# Access Compliance Report

## Public Rights-of-Way

### (Curb Ramps)

Intersection ID: 31771	Main Street: STARNES RANDALL RD	Cross Street: PINYON PINE LN	Location: S
ADA ID: 9B7A783D6A68	Ramp Type: Perp	Initial Pass/Fail: Fail	Overall Compliance: No
Severity Score: 12.5			
Codes/Mitigation Info/Possible Solution		Field Measurements/Component Compliance

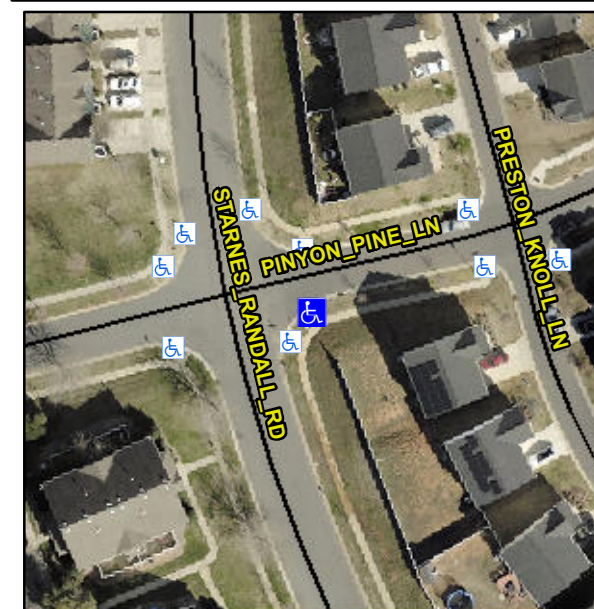
**Not Found, R304.5.3**

Compliance	Description	Data	Compliance	Description	Data
N/A	Ramp Length (in)	96.0	Yes	Ramp Slope (%)	5.5
Yes	Ramp Width (in)	160.0	No	Ramp XSlope (%)	6.4
N/A	Flare Type LT	N/A	N/A	Flare Type RT	N/A
N/A	Flare Slope LT (%)	N/A	N/A	Flare Slope RT (%)	N/A
N/A	Flare Traversable LT?	N/A	N/A	Flare Traversable RT?	N/A
N/A	Landing Length (in)	N/A	N/A	DWS Provided?	N/A
N/A	Landing Width (in)	N/A	N/A	DWS Contrast?	N/A
N/A	Landing Slope (%)	N/A	N/A	DWS Length (in)	N/A
N/A	Landing X Slope (%)	N/A	N/A	DWS Full Width?	N/A
N/A	Landing Curb? (Y/N)	N/A	N/A	DWS Offset (in)	N/A
N/A	Shared Landing?	N/A			
N/A	Gutter Ponding?	N/A	N/A	Gutter Slope (%)	N/A
N/A	Gutter Lip Ht (in)	N/A	N/A	Gutter X Slope (%)	N/A
N/A	Painted X Walk1?	No	N/A	Painted X Walk2?	N/A
	X Walk 1 Direction	To N		X Walk 2 Direction	N/A
N/A	X Walk 1 Width (in)	N/A	N/A	X Walk 2 Width (in)	N/A
	X Walk 1 Slope (%)	2.6		X Walk 2 Slope (%)	N/A
	X Walk 1 X Slope (%)	6.5		X Walk 2 X Slope (%)	N/A

**Remove & Replace Entire Ramp.**
